HUMAN FACTORS ASSESSMENT: M9 ARMORED COMBAT EARTHMOVER (ACE)

REPORT DOCUMENTATION PAGE		READ INSTRUCTIONS BEFORE COMPLETING FORM
1. REPORT NUMBER ARI Research Note 88-12	2. GOVT ACCESSION NO.	3. RECIPIENT'S CATALOG NUMBER

4. TITLE (and Subtitle) Human Factors Assessment: M9 Armored Combat Earthmover (ACE)		5. TYPE OF REPORT & PERIOD COVERED Final Report February 1983 - December 1985

Figure 4. Locations of the major human factors engineering deficiencies and safety hazards found on the M9 ACE. The drawings are from the Operator's Manual, Armored Combat Earthmover (ACE), M9 (TM 5-2350-262-10), Headquarters, Department of the Army, February 1984.

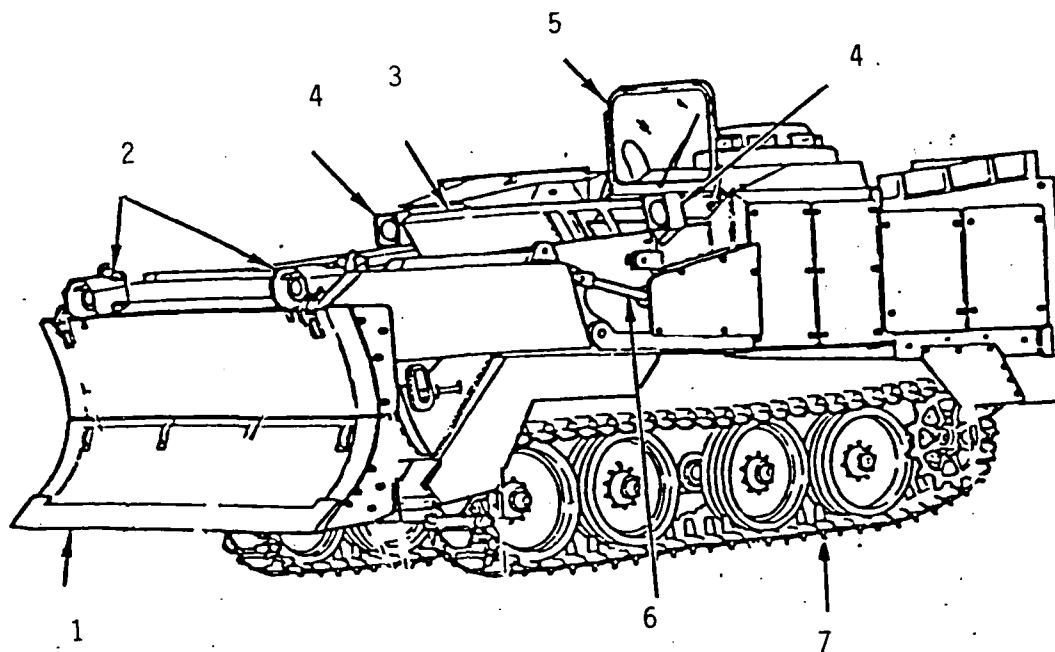
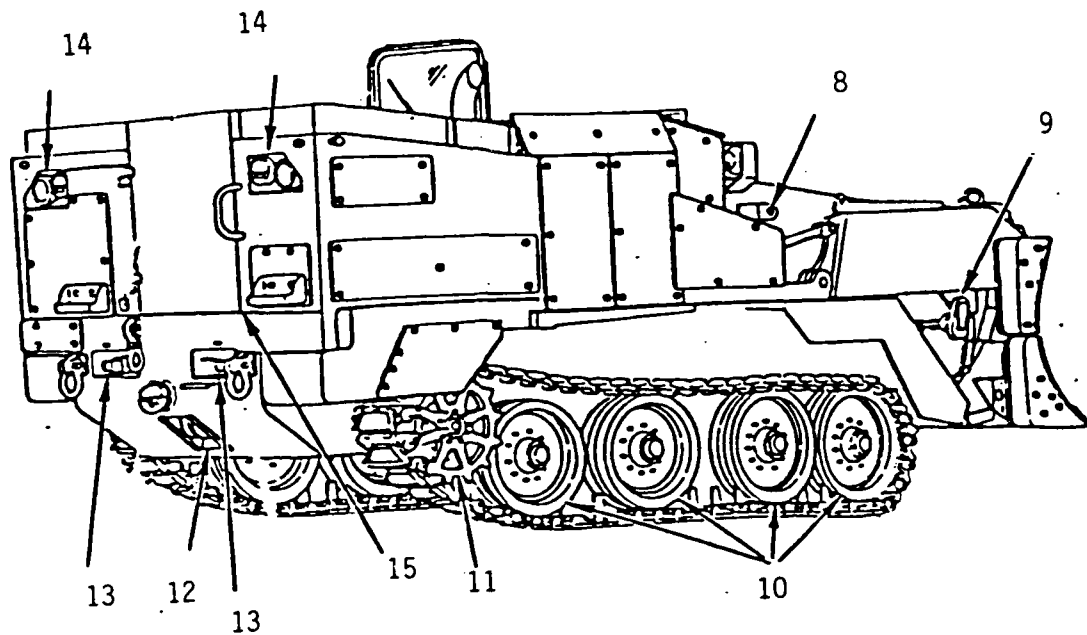
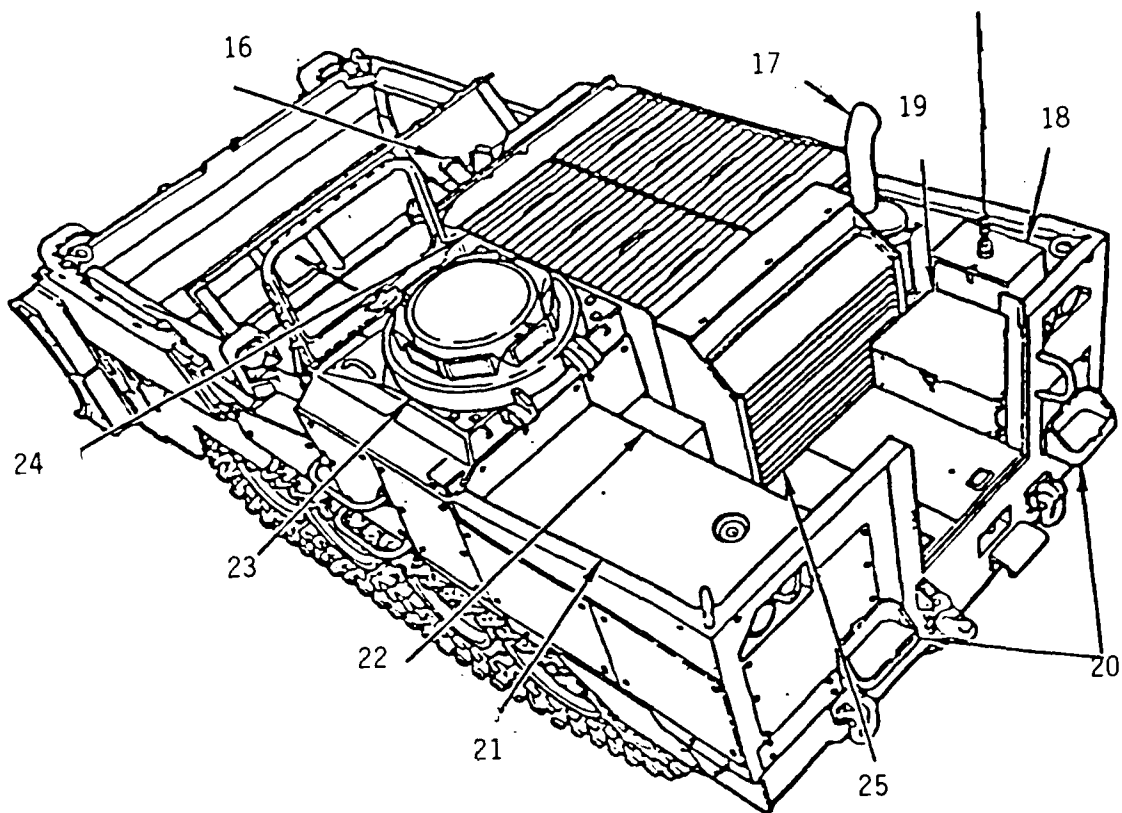
1. APRON AND DOZER ASSEMBLY. The operator must unsafely crawl beneath the dozer blade in order to prepare it for folding.
2. HEADLIGHTS. The lights do not conform to the Army Secure Lighting Program.
3. EJECTOR. There is no ejector blade lockout device to prevent its being retracted when personnel work in the bowl. The ejector cylinder (not shown) must be removed before other major components can be removed.
4. FLOODLIGHTS. The lights are frequently broken by collisions with trees.
5. WINDSHIELD. The windshield is frequently broken by collisions with trees.
6. APRON CYLINDER. The lubrication points are blocked by an armor panel.
7. TRACK. The track pads frequently wore out and may have increased vehicle vibration.

8. UPPER APRON LOCK PINS. Pin openings must be perfectly aligned in order to insert the pin. Two people are required to perform the task.
9. LOWER APRON LOCK PIN. The pins were difficult to remove due to the tightness of their fit. The pins were deformed by operators hammering them in and out of position.
10. ROADWHEELS. Rubber broke off the roadwheels and may have increased vehicle vibration. Roadwheels are hazardous to remove and replace.
11. FINAL DRIVES. The final drives must be drained in order to check the fluid levels.
12. WINCH ASSEMBLY. The winch is under capacity. The wire rope broke frequently. The wire rope wraps unevenly on the drum. There is no winch brake.
13. REAR STEP. The step was crushed in collisions.
14. TAILLIGHTS. The lights do not conform to the Army Secure Lighting Program.
15. REAR DOOR. The door is difficult to lift when installing or stowing it.

16. SMOKE GRENADE LAUNCHERS. The launchers are difficult to load from the sloped roof of the engine housing.
17. MUFFLER. Debris trapped in the muffler well was caught on fire. The radio cables were burned by heat generated from the muffler.

Figure 18. The damage to the rear of the vehicle. (The winch cable, the rear steps, the jerry can holders, and the handrails are broken.)

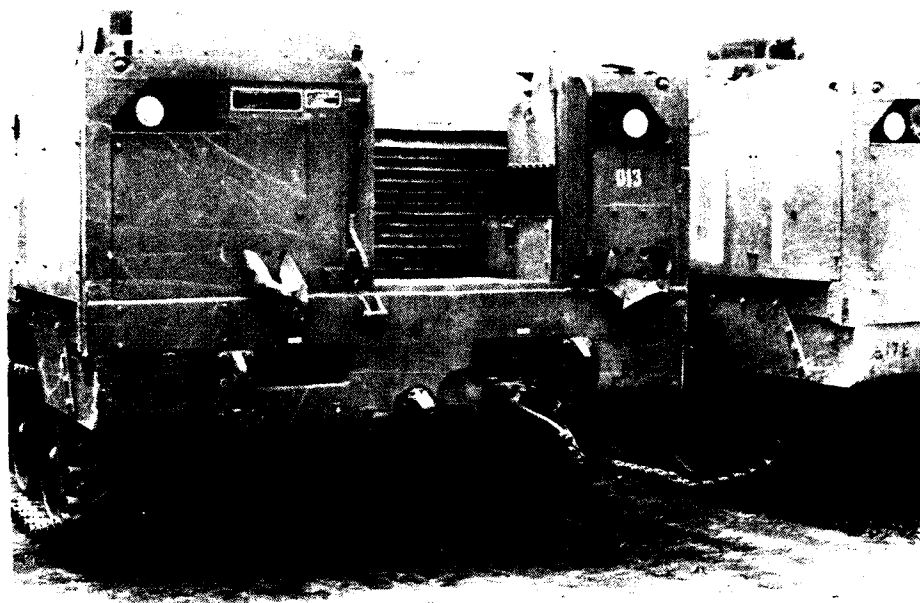
Description of the Deficiency: Table 17 lists the number of operators responding to questions concerning the space provided for stowage and its locations. Figure 18 shows damage to jerry can holders and other objects on the rear of the vehicle. Table 18 lists the specific stowage deficiencies for basic issue items (BII) and other equipment.

Implications for the Operator and the Equipment: Stowed equipment on the rear of the vehicle was frequently damaged by collisions with objects to the rear of the vehicle. Stowed equipment on the rear deck of the vehicle was affected by the high engine temperature. The stowed equipment blocked the air flow and affected the efficiency of the cooling system. Stowage locations that are difficult to access increase the time it

1. Add a rear bumper that extends along the lower rear of the M9 and up both of the outside edges. The bumper should be wider than any of the stowed items kept at the rear of the vehicle and the outside edges should be wide enough to deflect tree limbs. The rear bumper could also include an improved rear step and mount for the winch.

2. Increase the length and depth of the OMV tool box to accommodate the additional equipment (ie., the tanker bar, life jacket, canvas canopy, etc.).
3. Add steps and handholds to assist operators when climbing into the bowl in order to make access to the tool box easier and safer.

4. Add a mechanism on the tool box lid to lock it open and to avoid having it fall on the operator.
5. Add stowage compartments on the rear of the vehicle and protect them from being crushed.

Figure 19. The suspension control levers (center left) that are too close together.

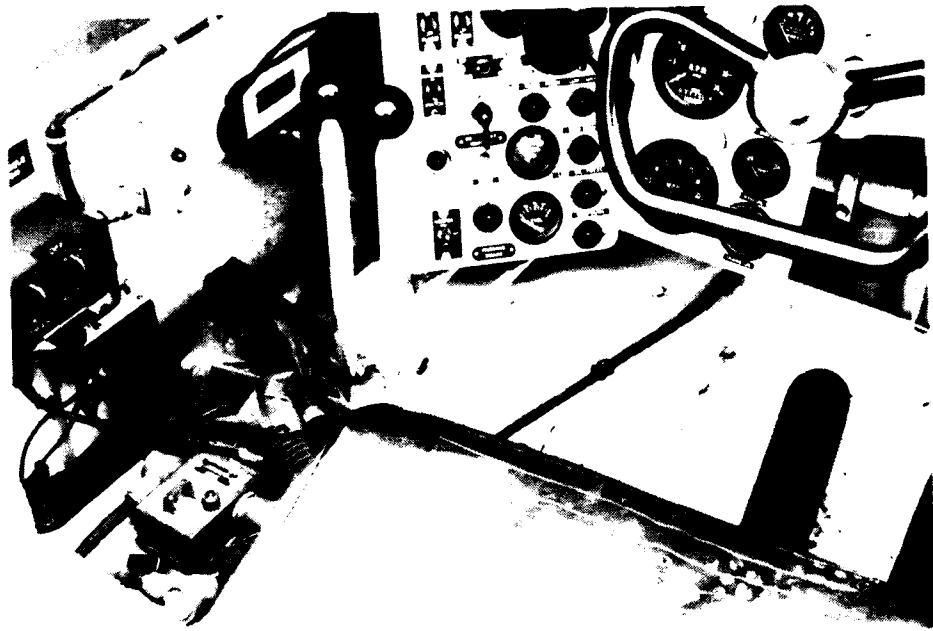
Control or Display	Problem Reported by	Deficiency	Implications for Operation of the Vehicle
Low oil and low air pressure indicator lights	2 operators	The indicator lights light too late to help prevent system failure.	Operator is not aware of decreasing pressures and cannot avoid pressure failures.
Clogged air filter indicator (see Fig. 25)	2 operators	The clogged filter indicator is located on the air filter in the engine compartment and not on the operator's display panel.	Operator may not detect a clogged air filter problem. The air filter may not be cleaned often enough.
Bilge pump "ON" indicator light (see Fig. 21, previously shown)	2 operators	The operator cannot see the bilge pump indicator light when the seat is raised for the open hatch position.	Operator may not detect a bilge pump failure to operate.
Left and right display panels	Human factors engineer	The gauge labels are above the gauges on the left panel and below the gauges on the right panel.	Operator may read the wrong gauge.

Figure 30. Damage to the floodlight guard

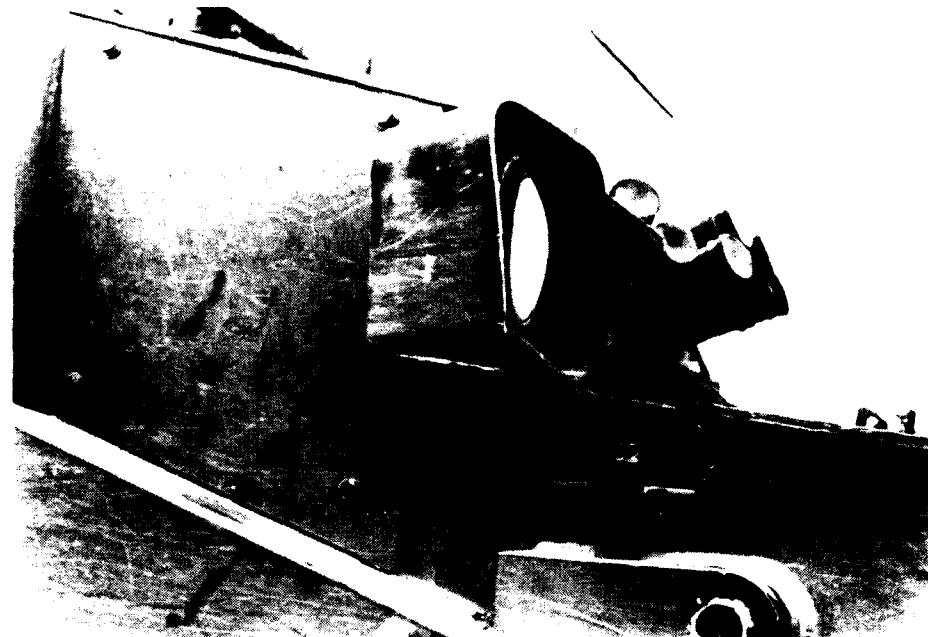
Description of the Deficiency: Figure 30 shows a damaged protective shield for a floodlight mounted on the side of the vehicle. The side mounted floodlights were frequently damaged by collisions with trees.

1. Place the side mounted floodlights in protected locations more inboard on the vehicle than the present locations. Perhaps, floodlights could be located inboard at a greater height on a removable stand or fixture.
2. Add lights meeting the requirements of the Army Secure Lighting Program.

Figure 33. Mechanic grasping the paddle lock bracket to open the hatch. (The night vision periscope is in place above the driver's hatch.)

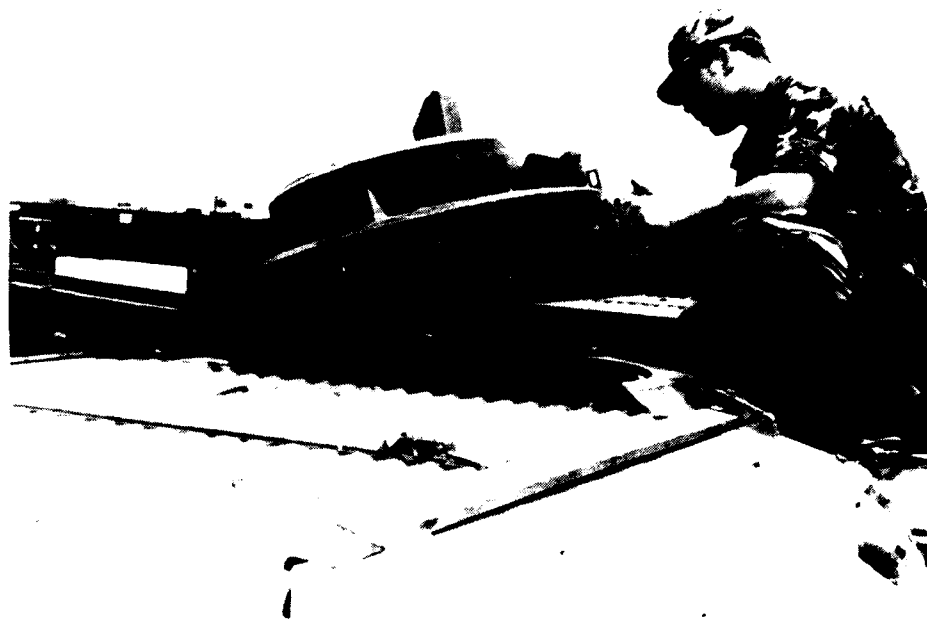
4. Figure 33 shows a mechanic grasping the bracket of the hatch paddle lock. There is no easy way to grasp the hatch in order to open it.

A pivot hatch arrangement may be a partial solution. If the height of the hatch interferes with loading onto the C-130 aircraft, then a hatch within a hatch may be required. The smaller upper hatch could be provided for operational use, while the entire top of the operator's compartment can be hinged to fully open (like the hatch presently opens) for loading the M9 onto aircraft.

Figure 37. An operator attaching the chain to the ejector blade and positioning it down the center of the dozer blade. (NOTE: The chain passes through the stowage area above the dozer blade.)

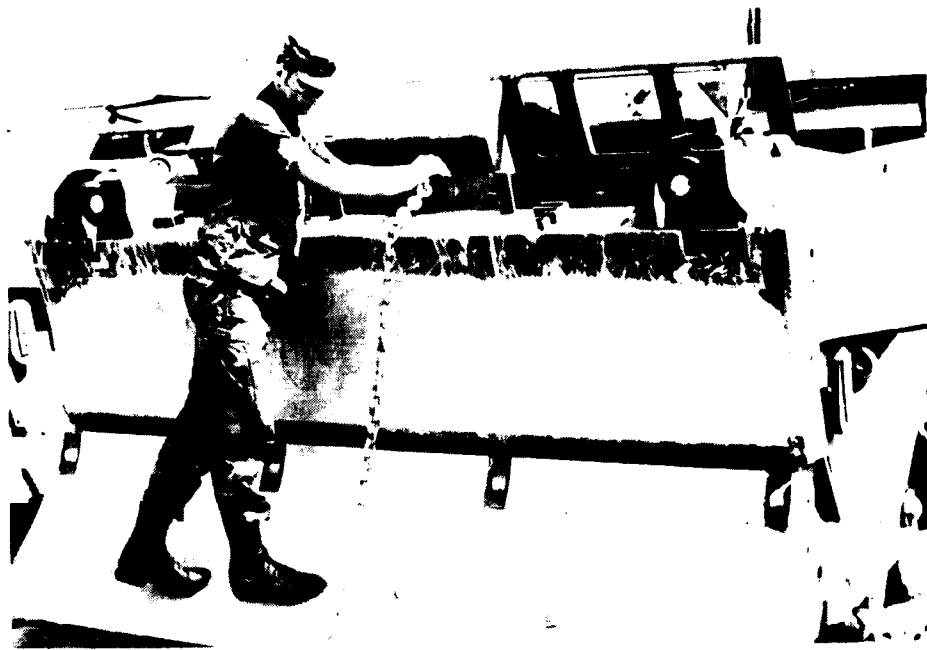
Description of the Safety Hazard: Two operators reported that folding the dozer blade was hazardous. Figure 36 shows an operator crawling beneath the dozer blade in order to attach a chain to a shackle beneath the blade. The vehicle suspension must be raised (sprung) and supported with blocks in order to prevent the dozer blade from descending on the operator as a result of pressure changes in the hydraulic system. The support blocks were unavailable in the field and earth berms, which could collapse, were used to support the dozer blade.

An alternative to the procedures involves raising the apron and dozer blade allowing the operator to stand beneath the dozer blade to attach the chain. However, the additional steps add approximately 15 minutes to the 20 to 30 minutes procedure. The additional time results from removing and replacing the apron pins (see Deficiency: Apron and Dozer Blade Lock Pins, pg 64). Moreover, unless the apron is fully raised and locked with its safety pins (making the shackle difficult to reach) the dozer blade and apron could fall on the operator, again as a result of pressure changes in the hydraulic system.

Figure 42. The eight engine grille panels.

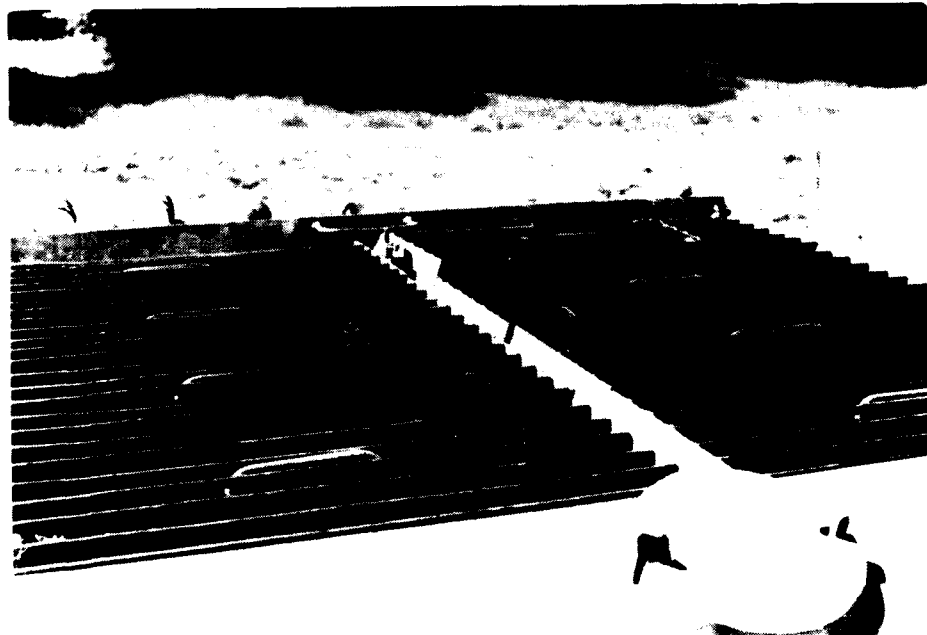
Description of the Safety Hazard: Figure 42 shows the eight engine access grilles in place above the engine. Three mechanics and four operators reported that the weight of the exhaust grilles (approximately 50 lbs (22.6 kg)) discouraged the operators from performing PMCS checks. Moreover, there is no safe way to stand above the grilles to remove them as the surfaces in front and to the rear of the grilles are sloped and slippery (safety hazard).

1. Reduce the weight of the grilles. Use a lighter material for the grilles other than steel (ie., aluminum).
2. Make the grille sections into one piece that is hinged and can be raised and supported like the hood of a truck.

Figure 43. A damaged winch cable and the cable unevenly wrapped on the winch drum.

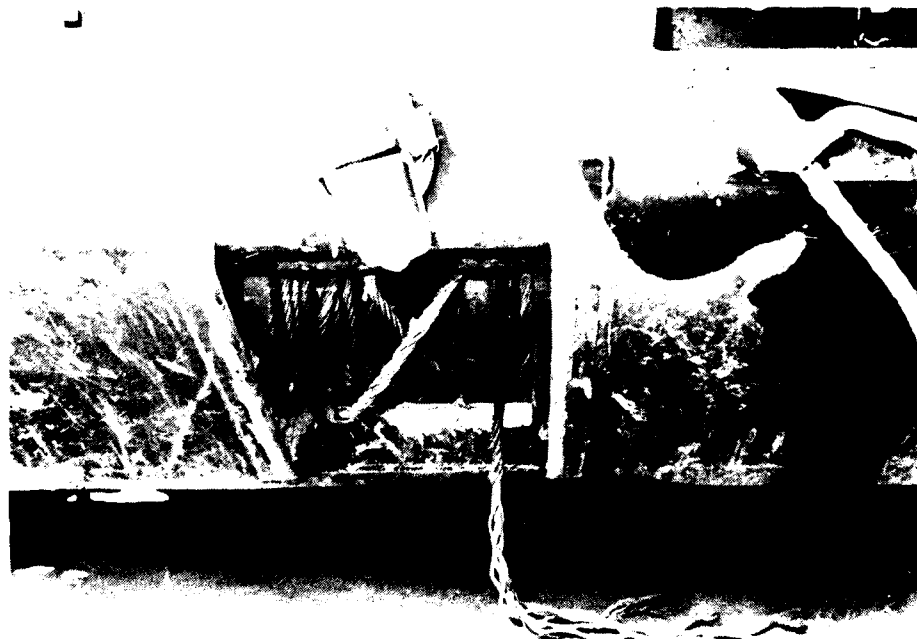
Description of the Safety Hazard: Figure 43 shows a frayed and broken winch cable improperly wrapped on the winch spool. Operators experienced several problems using the winch and many problems resulted in wire rope failure. The problems included:

1. There was no winch brake on the winch.
2. The winch had to be moving in order to shift gears.
3. The winch capacity is only 30,000 lbs, while the vehicle weighs approximately 55,000 lbs, when the bowl is full and the vehicle is likely to become stuck. Most of the wire rope failures occurred during self-recovery operations.
4. The wire rope wrapped itself unevenly on the drum which causes damage to the wire rope. The operators could not see whether the wire rope was wrapped appropriately as the winch was spooling it in.

Implications for the Operator and the Equipment: The winch is under capacity for most self-recovery operations. Often another M9 would use its winch in combination with the winch on the stuck M9 (double winching), yet cables broke when the double winching method was used. The depth of mud in which the M9 is mired doubles or triples the weight capacity required of the winch in order to pull the mired vehicles (FM 17-20). Thus, a winch capacity of 30,000 lbs is insufficient for a combat loaded M9 weighing 34,800 lbs with its bowl empty and mired up to its hull (a depth of mire that doubles the weight factor of the vehicle by friction and suction to approximately 68,000 lbs). Shackles and snatch blocks can be used to increase the mechanical advantage of the winch by folding the wire rope. However, shackles and snatch blocks limit the length the wire rope can be extended (refer to FM 17-20).
